Addendum No. 2
To the Plans and Specifications of

Escambia County Fire-Rescue
Paradise Beach – Station 20
1250 Bauer Road
Pensacola, Florida

Four Pages + Attachment(s)
August 4, 2026

A101
FLOOR PLAN

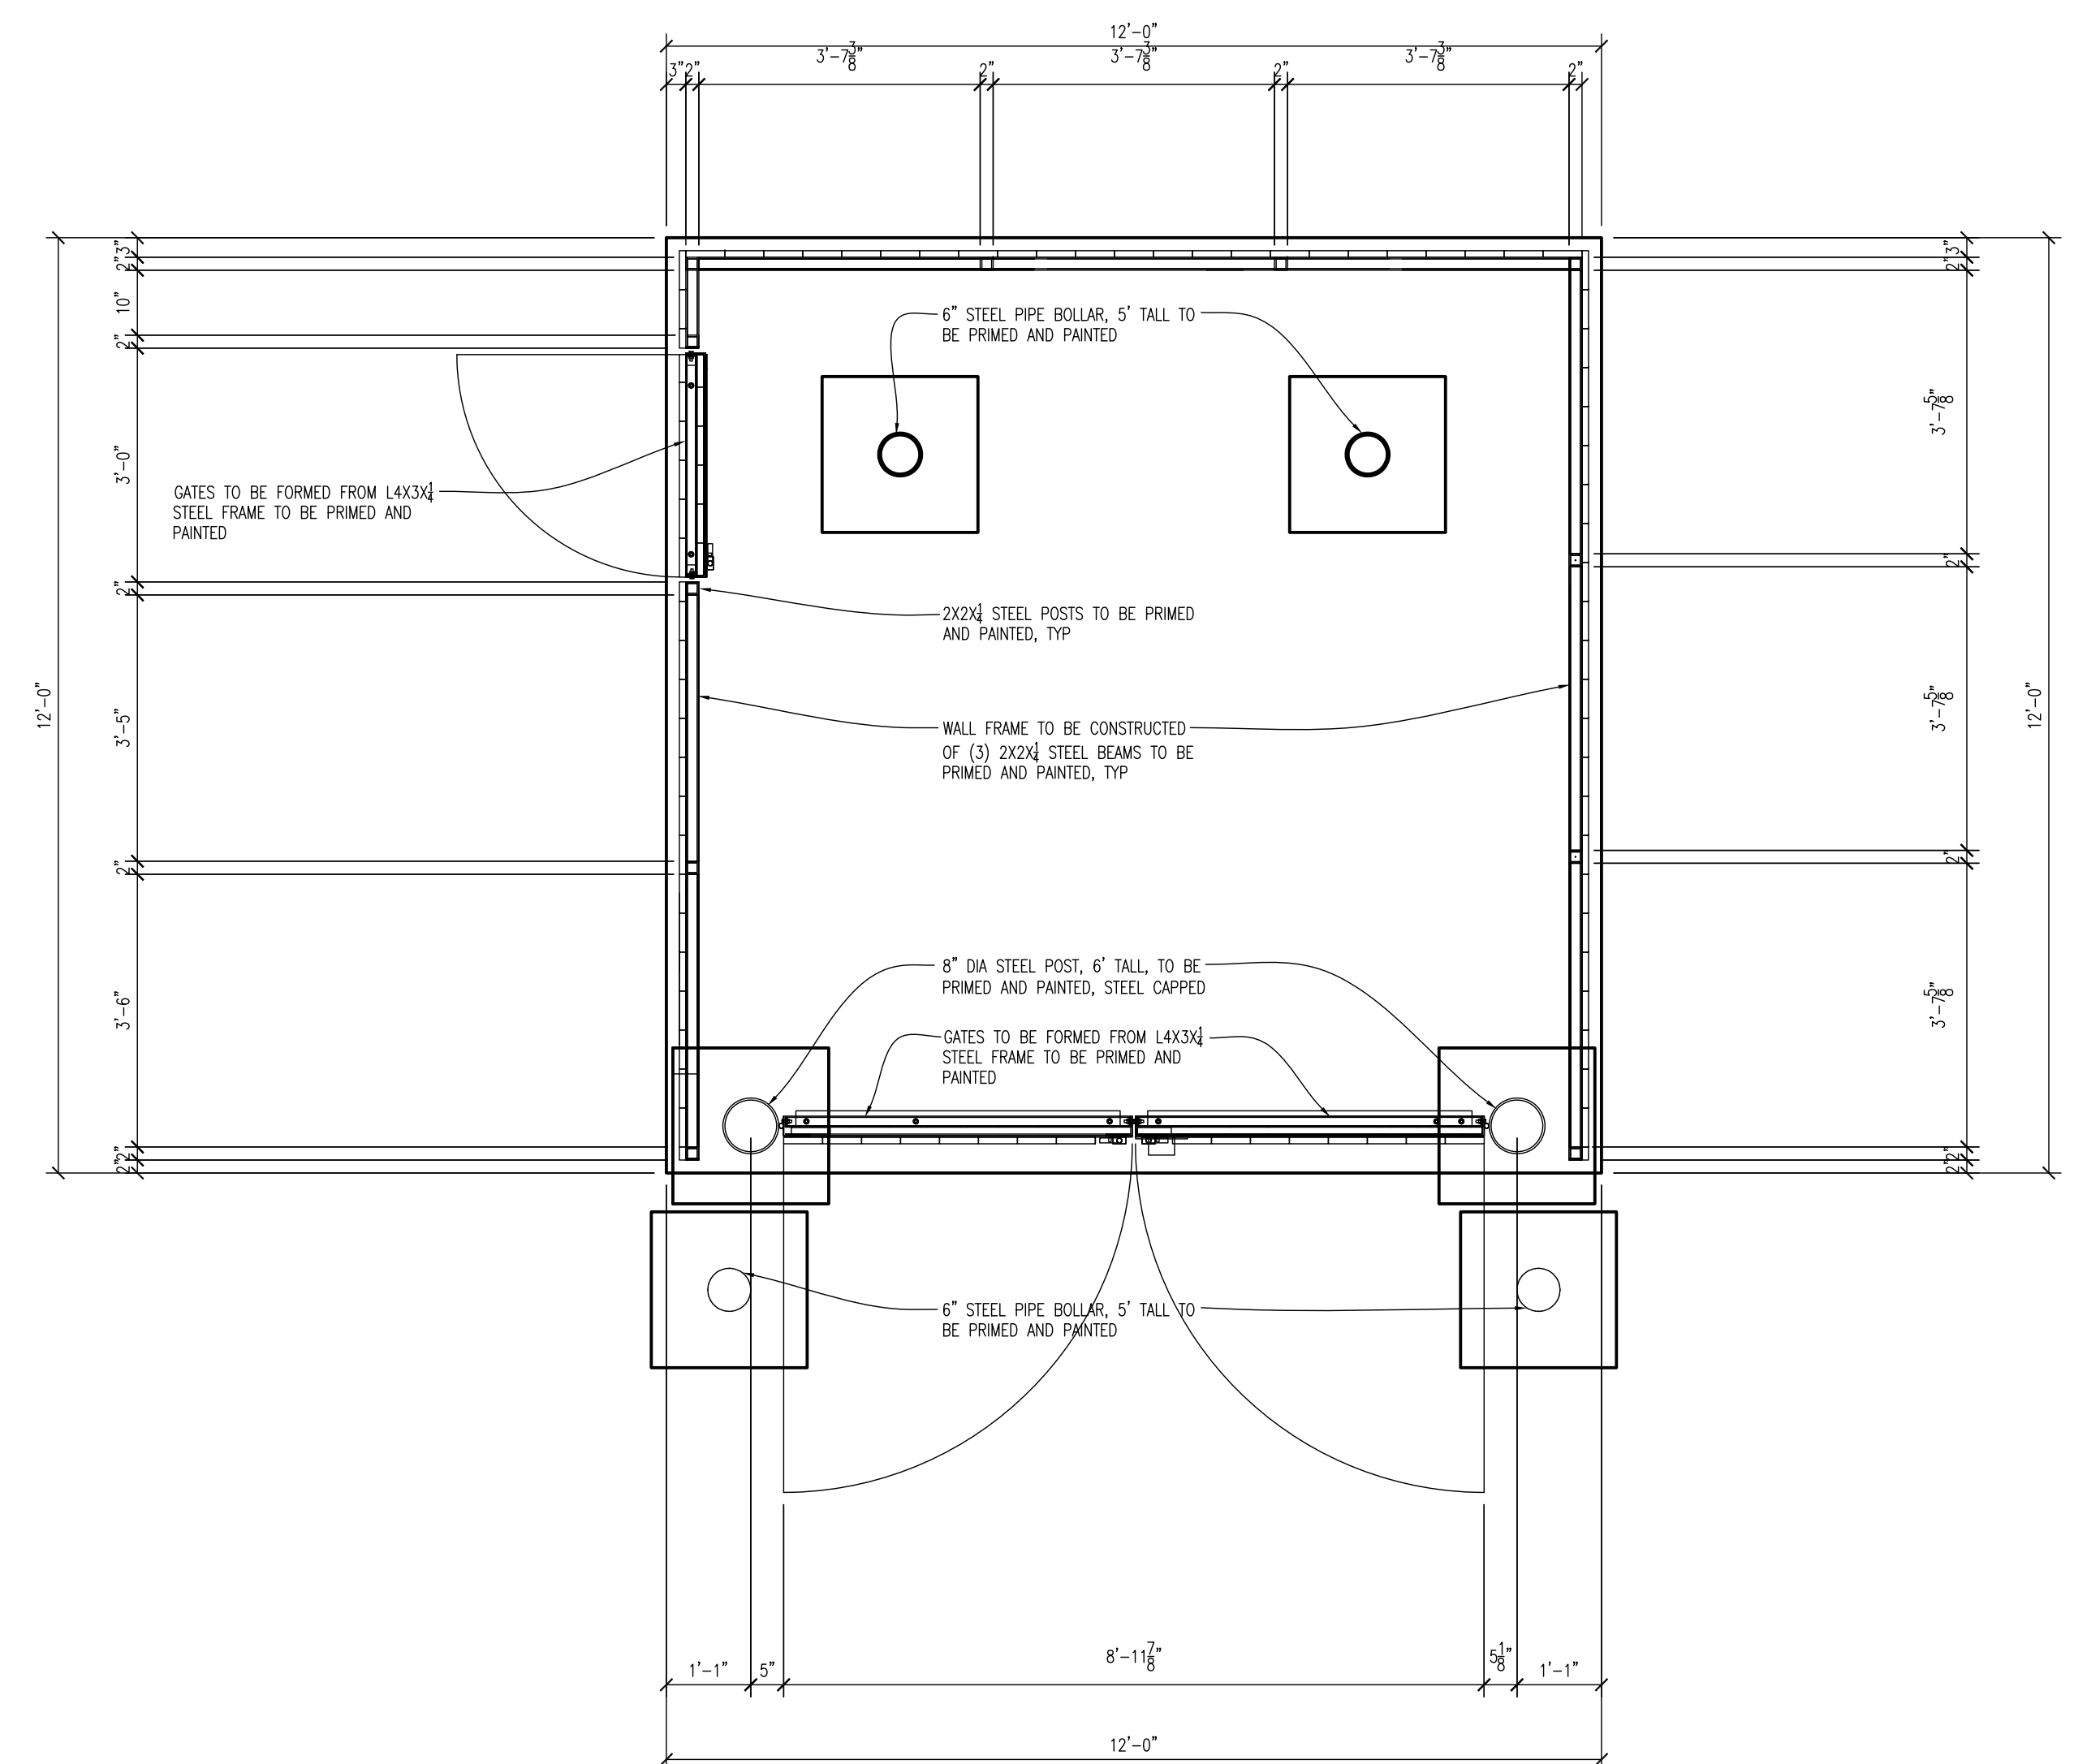
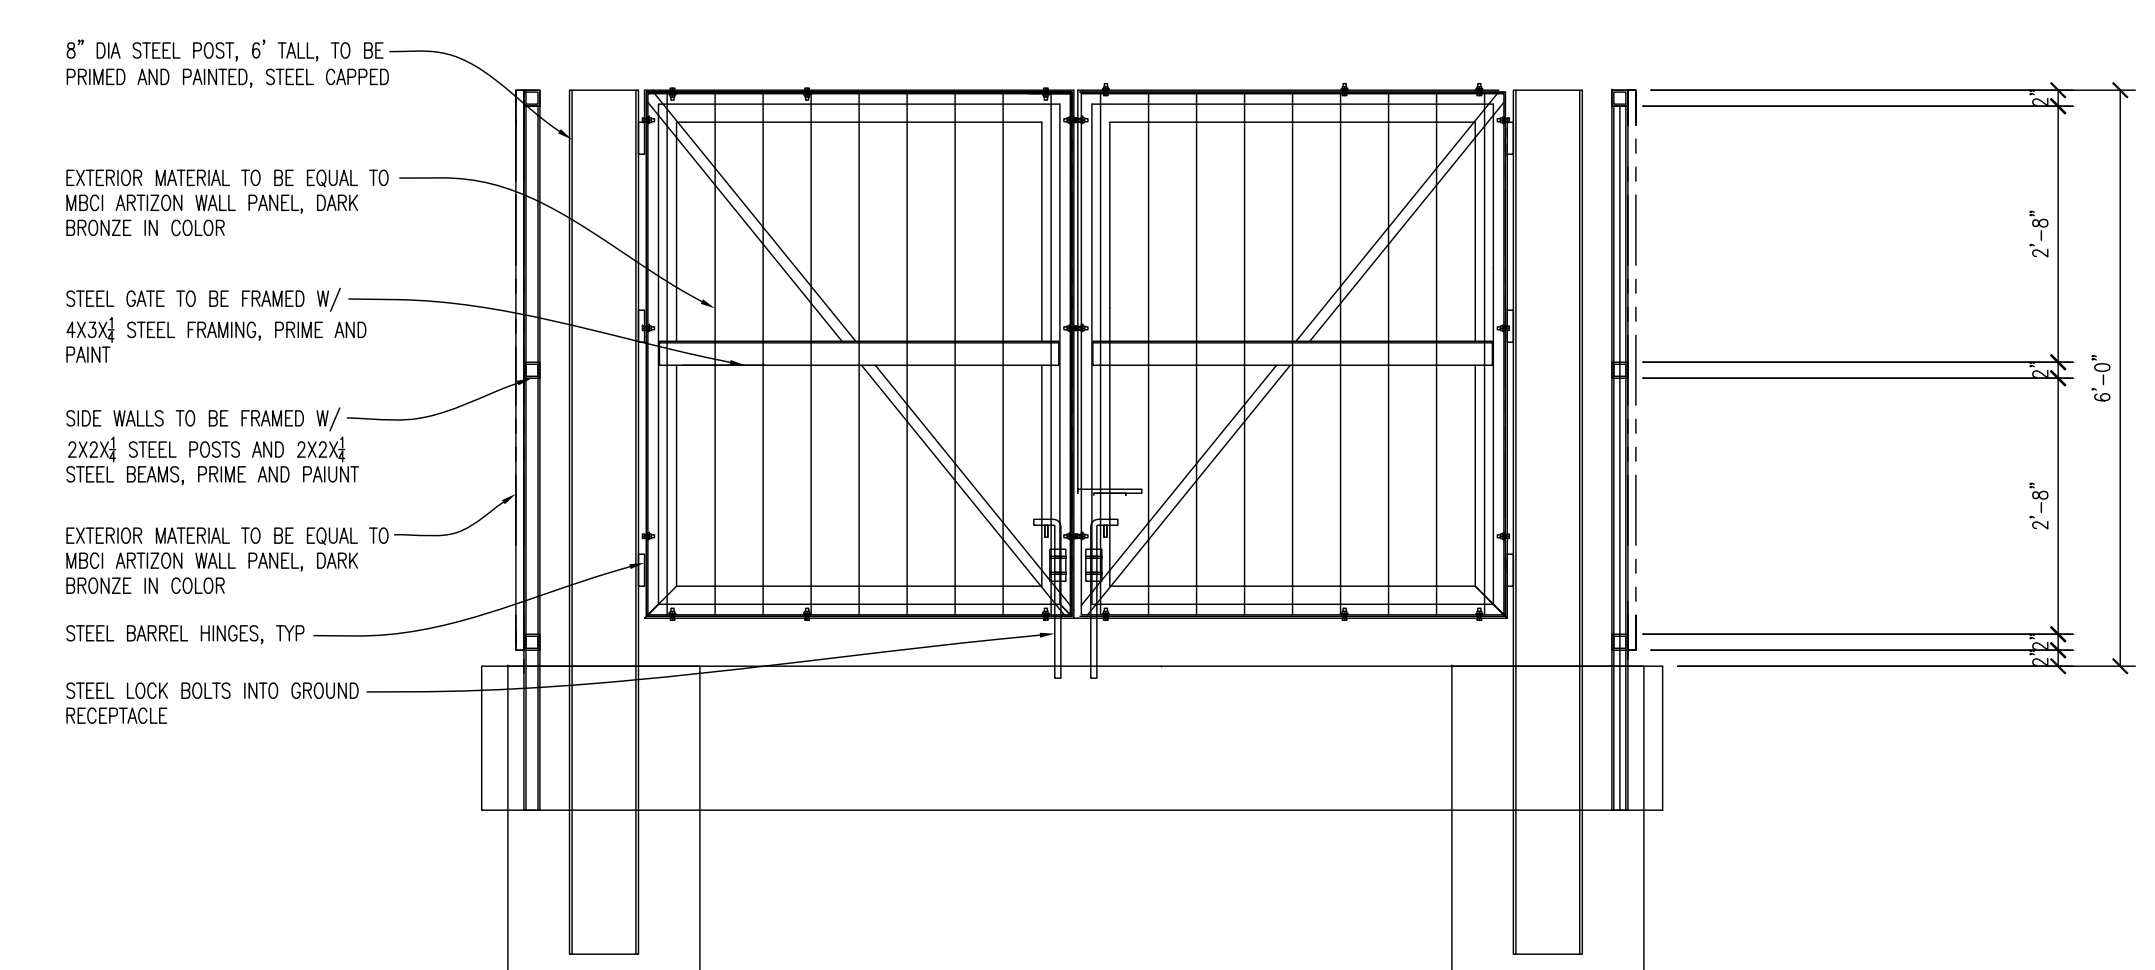
- A1. Sheet A103 – Add one addition #063 Semi-recessed fire extinguisher cabinet to apparatus bay.
- A2. Sheet A101 – The fire marshal is requiring that the walls that separate the dorm rooms from the corridor be classified as smoke partitions. See enclosed revised Sheet A101 for location of smoke partitions. Since these walls are already scheduled to be constructed from floor to roof deck, they do comply with this requirement. Walls will need to be sealed to bottom of vinyl backed insulation at roof deck. Any penetrations through these corridor walls will need to be sealed with sealant that meets requirements of a smoke partition. USG Firecode Smoke-sound sealant should be applied beneath the bottom track of stud wall.

SIGN SCHEDULE

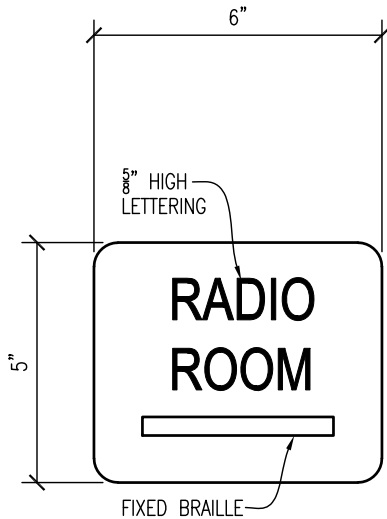
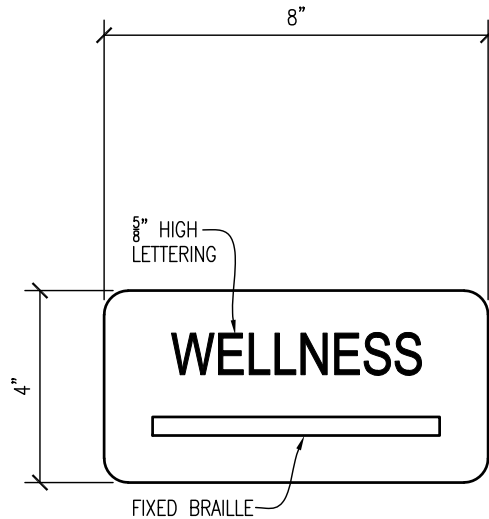
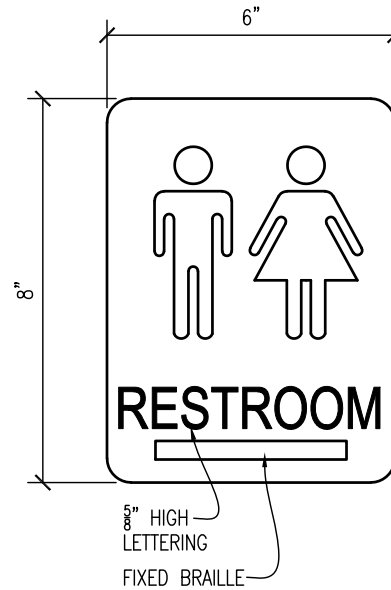
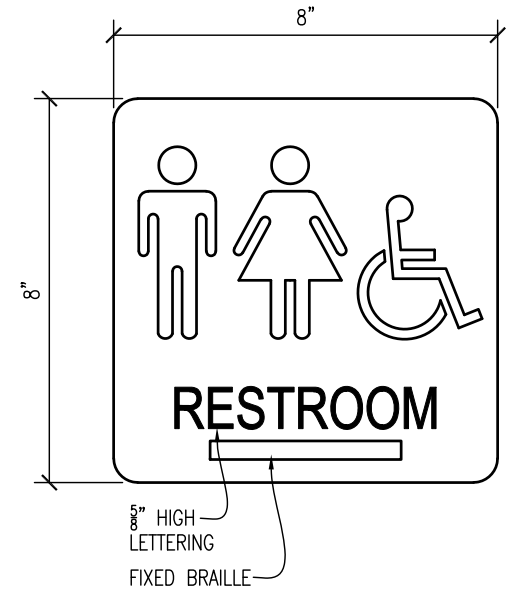
- A3. Sheet A507 – See enclosed new detail of dumpster screen plan and elevation.
- A4. Interior Sign Schedule – See enclosed new drawing for interior sign schedule.
